AMPEX

MAGNETIC RECORDERS

SERVICE BULLETIN

DATE: 20 March 1953
MODEL: 300
BULLETIN NO: 2
PAGE NO: 1

REMOVAL OF CAPSTAN ASSEM.

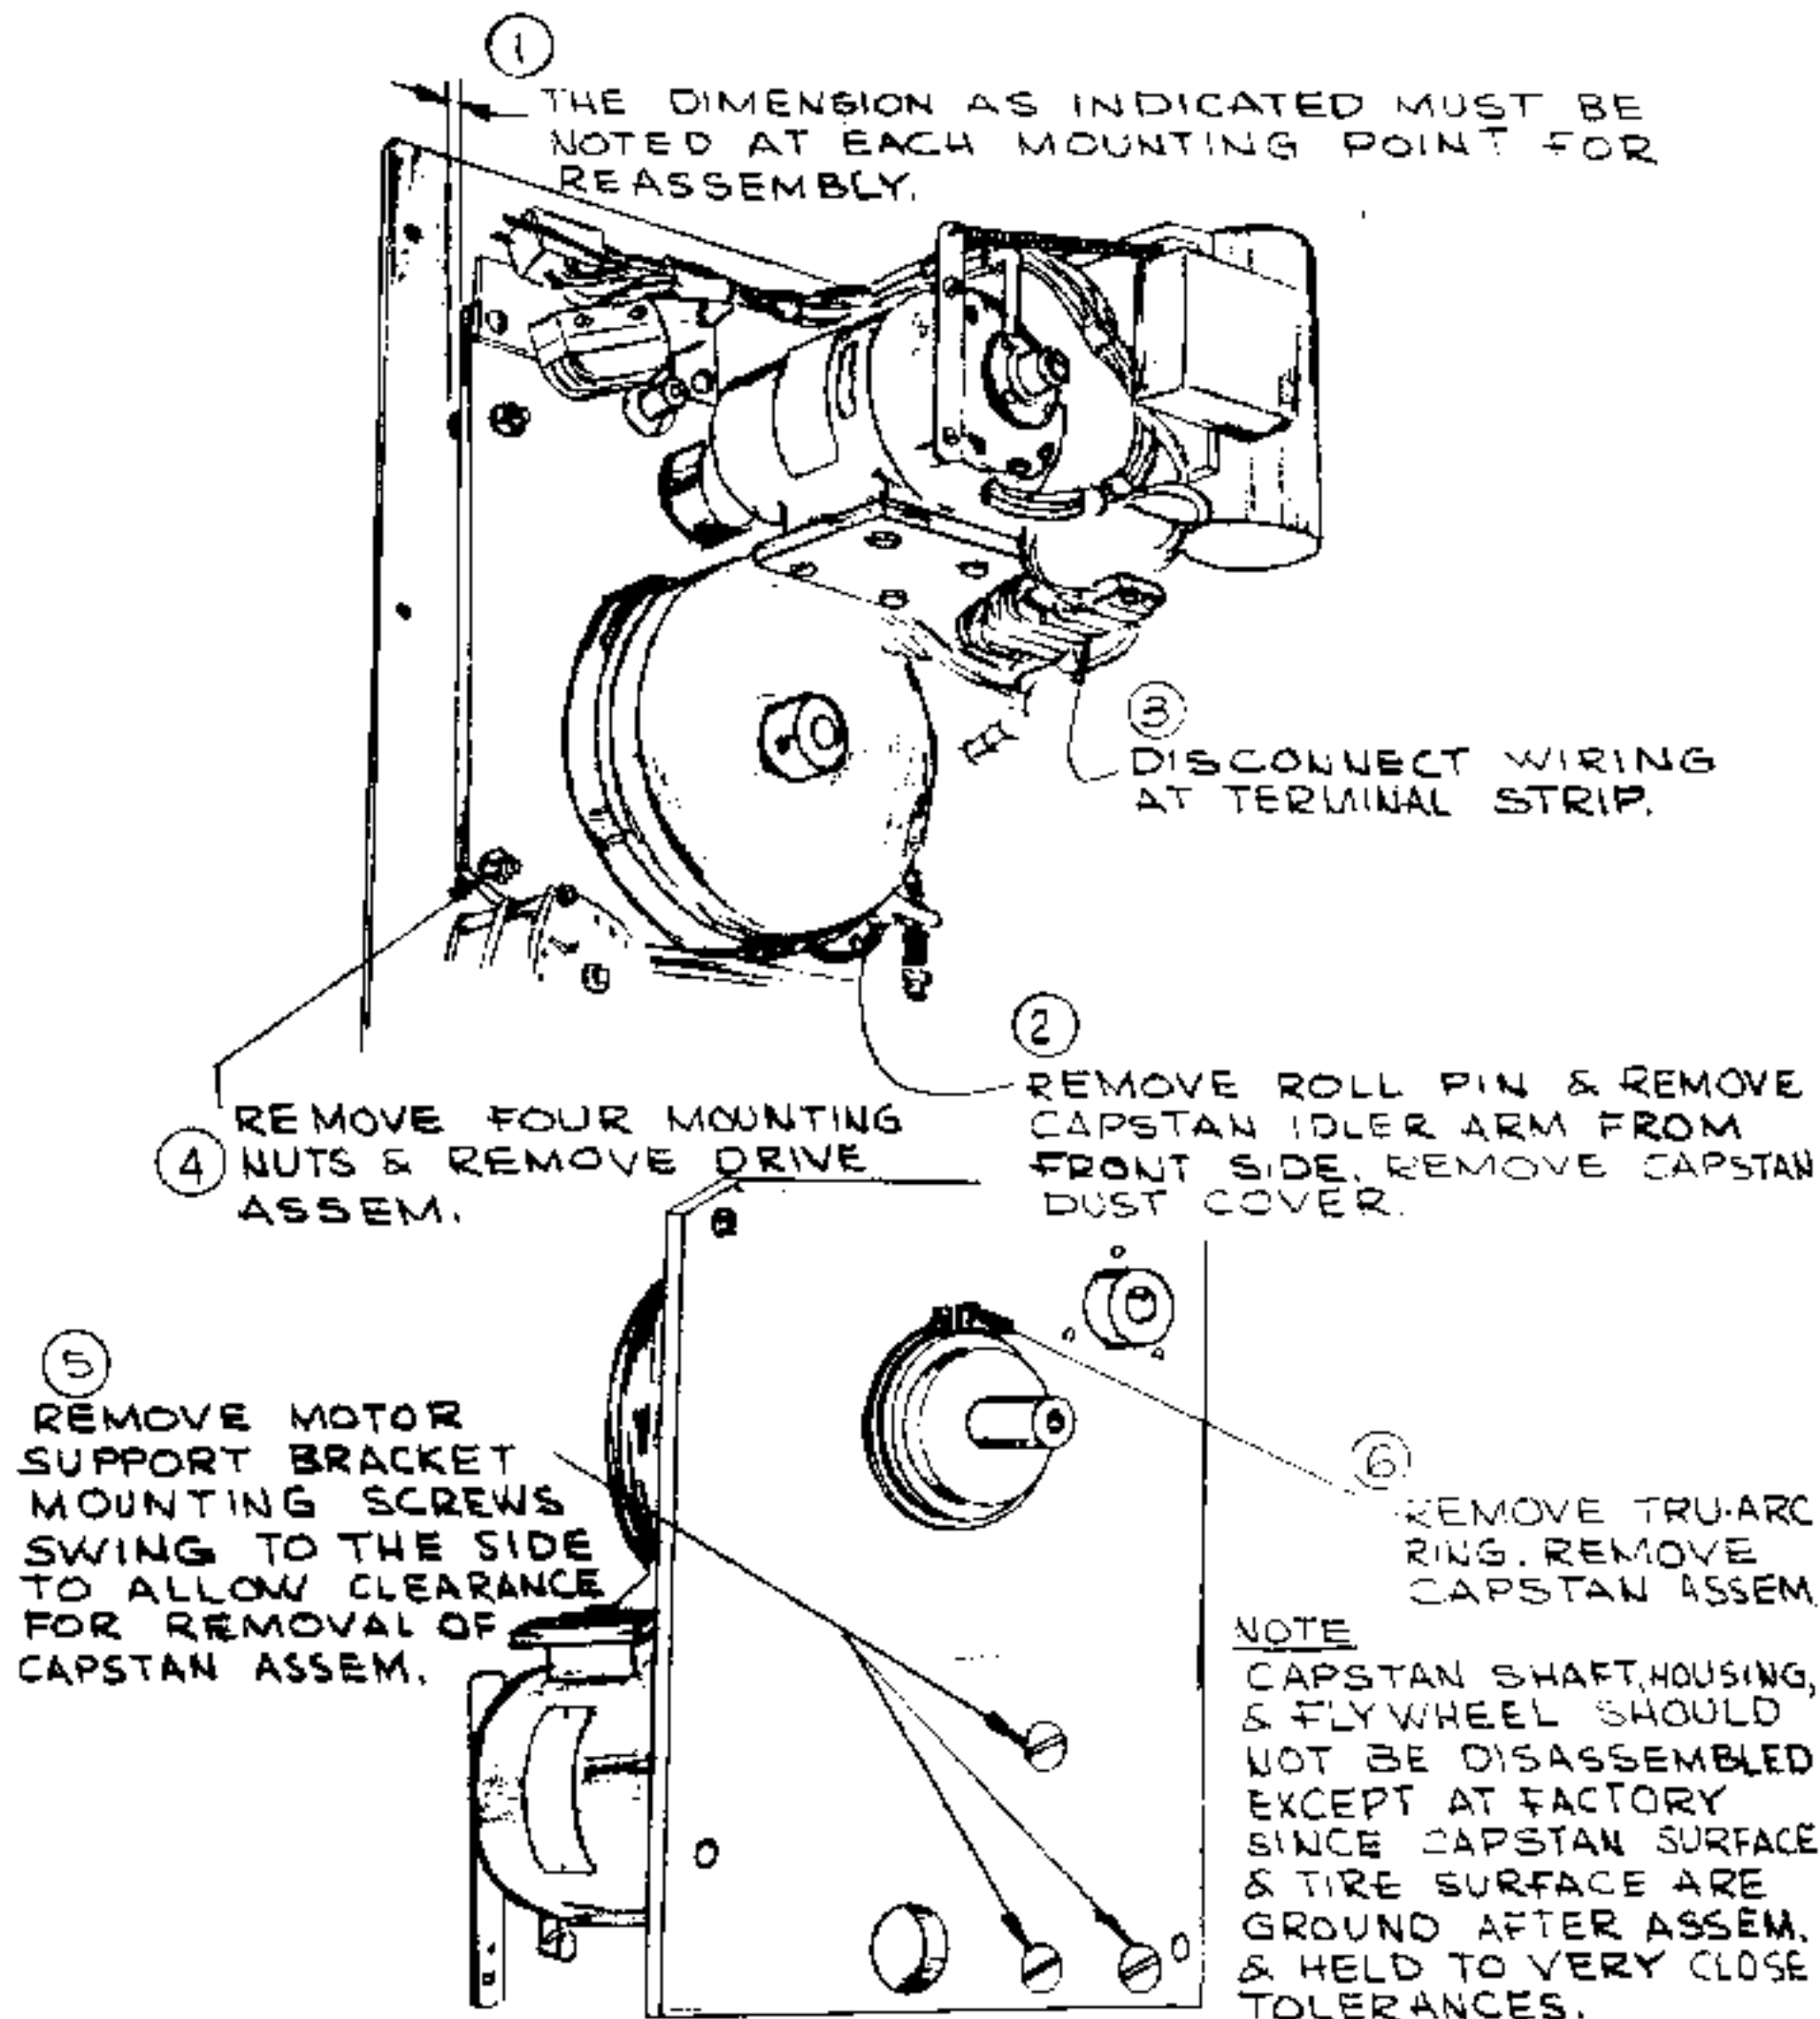
NOTE. NUMBERED BALOONS INDICATE SEQUENCE OF DISASSEMBLY. REVERSE SEQUENCE FOR REASSEMBLY.

FIG. 6

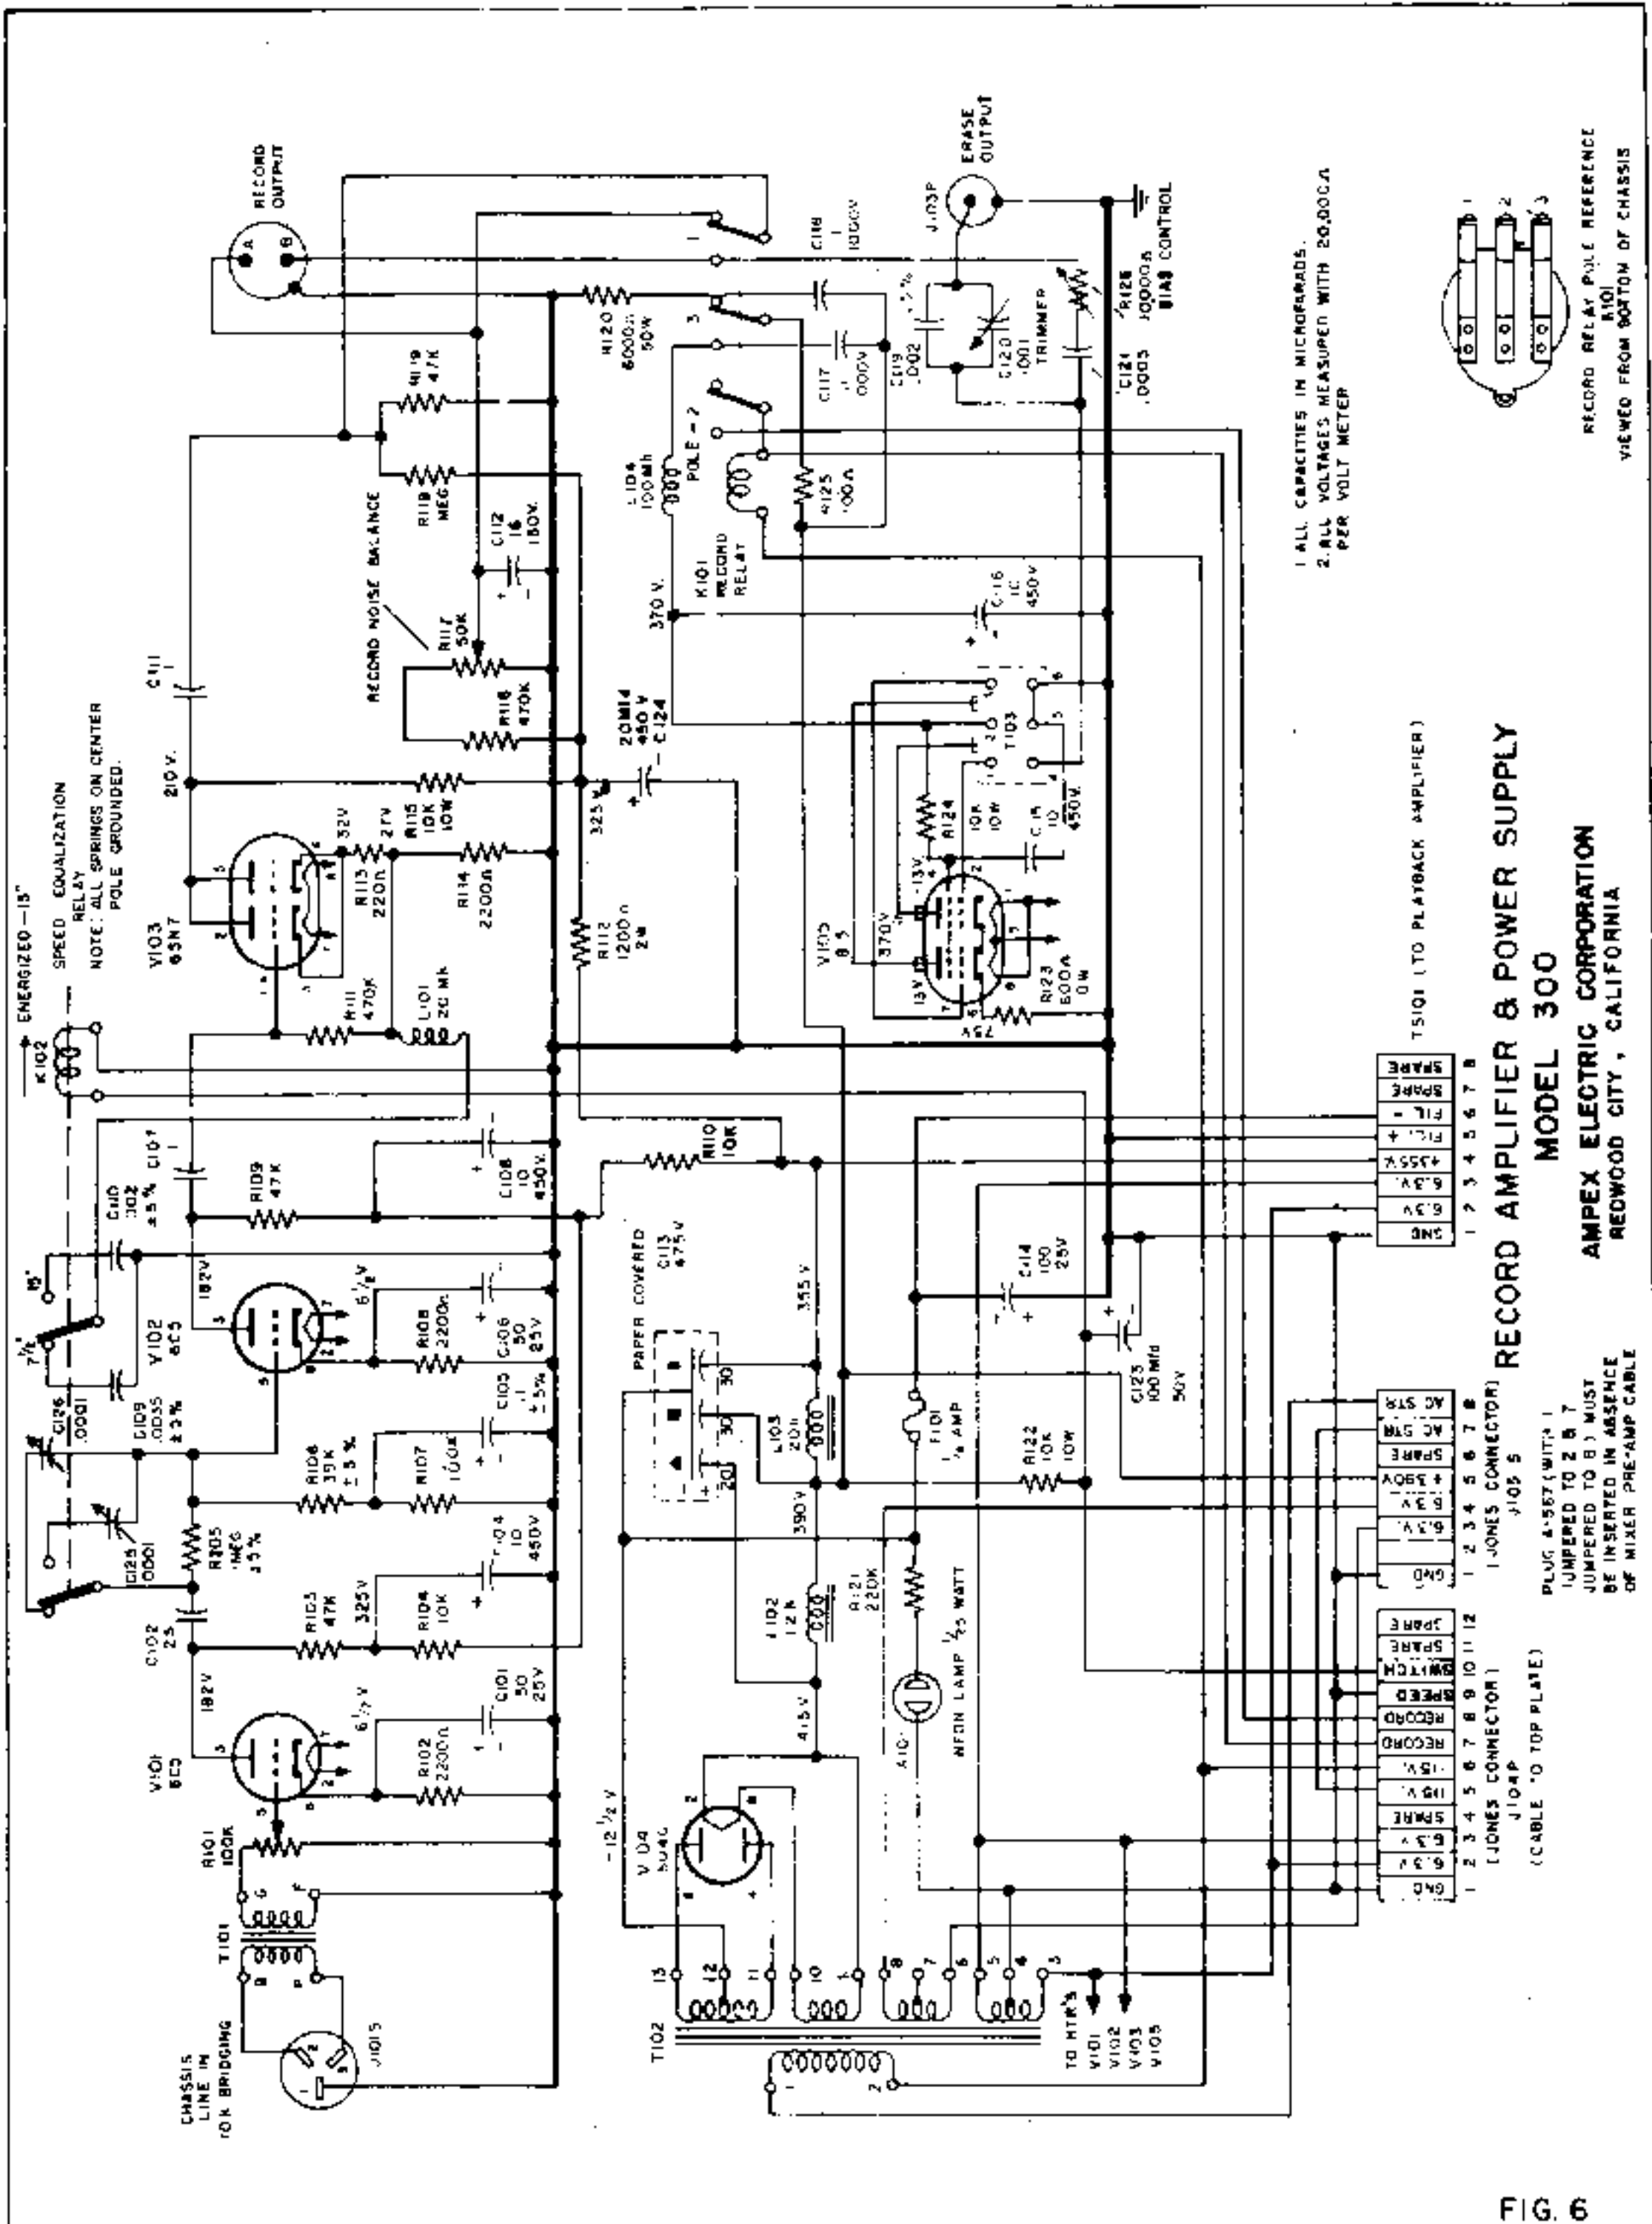
(Refer to record amplifier diagram for the following steps)

2. In the record amplifier, R106 must be changed to a 39,000 ohm $\pm 5\%$ 1 watt resistor. This resistor is Catalog #RE-44.
3. Condenser C123, a 100 mfd 50 volt condenser, Catalog #CO-63, must be added as shown on diagram.

4. Relay K102, Catalog #RL-2, should be added as shown. On J104P jumper terminals 1 and 9. Lead from R122 to terminal 2 on J105 should be reconnected to terminal 10 on J104P. Disconnect lead to terminal 10 on J104P from C109 (for this change compare new schematic with schematic furnished with original instruction book.)

5. Wire lead from bottom side of L101 to one outside rotor contact of J102. Connect to stator contacts of this section of the relay the new C109, Catalog #CO-10, and C110, Catalog #CO-21, condensers as shown.

6. Connect rotor of other outside relay section to the point between C102 and R105. Add the new trimmers C125 and C126, both bearing Catalog #CO-92, to stator contacts of this section as shown on attached diagram.
